UNITED NUCLEAR  
CORPORATION  
CHEMICALS DIVISION  
FEBRUARY 24, 1964

SUBJECT: SNM-33 AMENDMENT TO INCLUDE SHIPPING CONTAINER BE-1351

THE FOLLOWING IS SUBMITTED IN ACCORDANCE WITH OUR DISCUSSION OF FEBRUARY 20<sup>th</sup> PERTAINING TO AMENDMENT OF SPECIAL NUCLEAR MATERIAL LICENSE SNM-33 TO INCLUDE OUR SHIPPING CONTAINER IDENTIFIED AS BE PERMIT 1351. PLEASE MAKE THE FOLLOWING CHANGES IN "GENERAL INFORMATION AND PROCEDURES APPLICABLE TO THE HANDLING OF SPECIAL NUCLEAR MATERIAL" AS REVISED THROUGH DECEMBER 15, 1963:

SK-5 REVISED 2/24/64

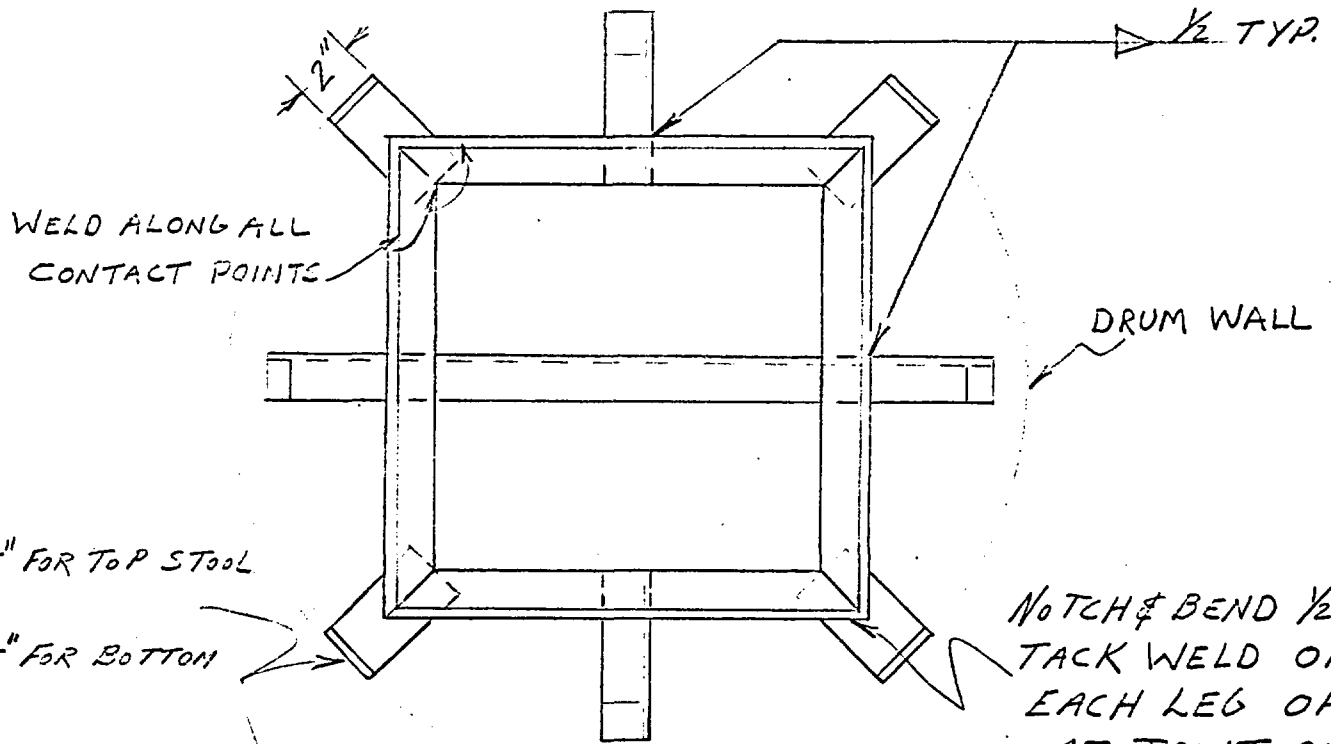
REPLACE SK-5 WITH SK-5, REVISED FEBRUARY 24, 1964

THE ASSEMBLED ARRANGEMENT OF THE CONTAINER IS SHOWN ON SKETCH SK-5 REVISED 2/24 WITH DETAILS OF THE SUPPORTING STOOLS AND INNER POT OR CONTAINER SHOWN ON SKETCHES SK-23 AND SK-23-1, REVISED FEBRUARY 24, 1964.

THE INTERNAL CONSTRUCTION OF THE CONTAINER IS SHOWN ON DRAWING SK-5 REVISED FEBRUARY 24, 1964 AND SK-23-1 REVISED FEBRUARY 24, 1964. THE 15 GALLON DRUM IS A STANDARD ICC TYPE 37-A-350 DRUM FABRICATED FROM 20 GAUGE STEEL. THIS DRUM WAS DROP TESTED FROM A HEIGHT OF 30 FEET. A DROP ON THE END RESULTED IN LESS THAN A FIVE PERCENT CHANGE IN THE SPACING BETWEEN THE BOTTOM OF THE DRUM AND BOTTOM OF THE "POT". A DROP ON THE SIDE RESULTED IN A MAXIMUM REDUCTION OF 1/4" ON THE DIAMETER OF THE DRUM (CORRESPONDING TO A MAXIMUM REDUCTION OF 1/4" IN THE SPACING BETWEEN THE DRUM AND POT ON THE SIDE OF THE IMPACT). THE MINIMUM DRUM DIAMETER IS THEREFORE 14 3/4". THE NET VOLUME OF THE DRUM AFTER THE DROP IS THEREFORE 1.7 CUBIC FEET. FROM FIGURE 23 OF TID-7016, REVISION 1, AT LEAST 20 SUCH UNITS IS A SAFE QUANTITY.

PHOTOGRAPHS OF THE DROP TESTS ARE ENCLOSED. (NOTE: THE END DROP WAS MADE WITH A CONTAINER BEFORE THE MODIFICATIONS SHOWN ON THE REVISED SKETCHES SK-5 AND SK-23-1 WERE MADE. THESE MODIFICATIONS WILL NOT EFFECT THE RESULTS OF THE END DROP.) FIVE ADDITIONAL COPIES OF THESE PHOTOGRAPHS WILL BE SENT WITHIN A WEEK.

JOB NO. SK-23-1 REVISED  
2/24/69

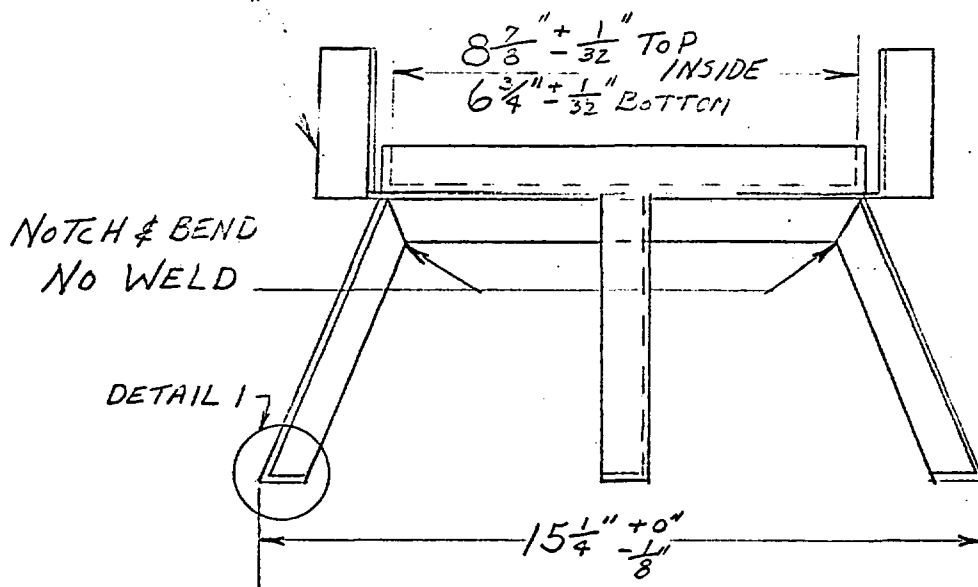
REPLACE SK-23-1 WITH SK-23-1 REVISED FEBRUARY 24, 1964
